Product Change Notice (PCN)

Subject: Add assembly and testing site of USB3.0 Host/Hubb controller devices

USB-ASSP PCN changing points

Doc No. APTE4-BB-21-0007

Table 2-1 UPD720201K8 IC Tray specification
ASH-SH(P/N JT5080801-01 REV.B)

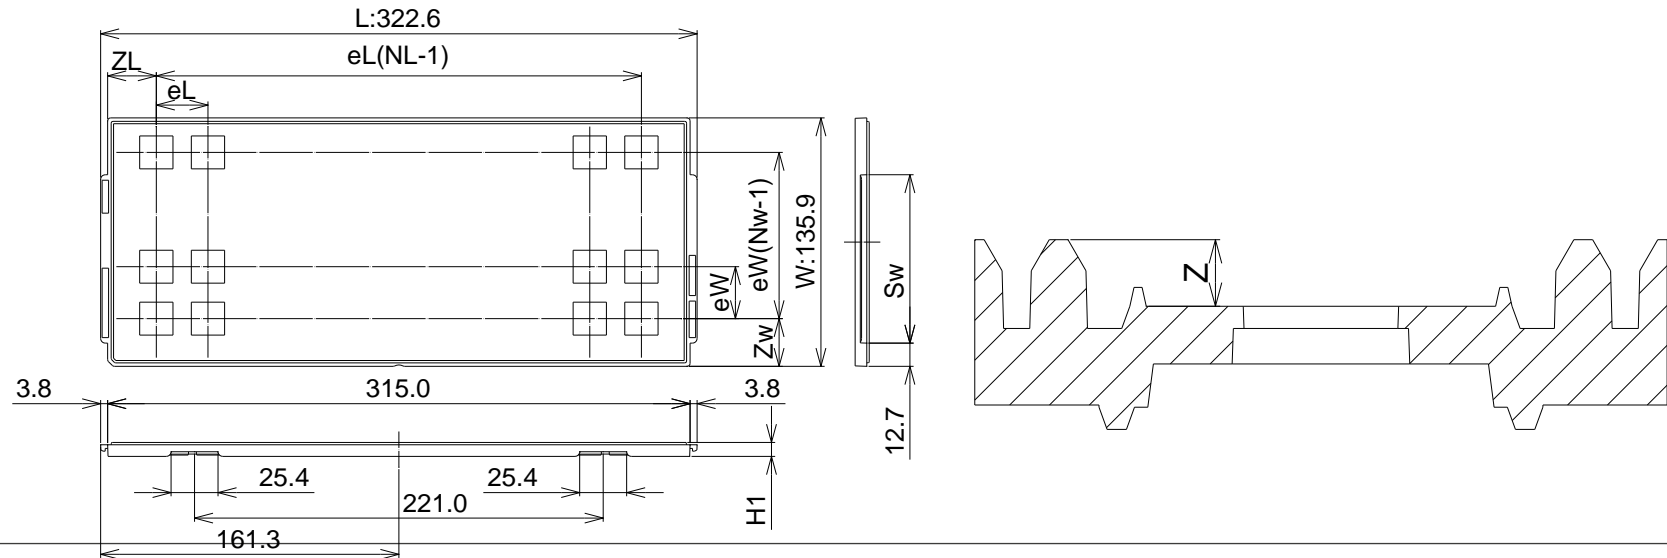
IC Tray: Adopting different IC Tray between existing site and new site.

Two type IC tray will be used for shipping forms. Pleas see in page9-11
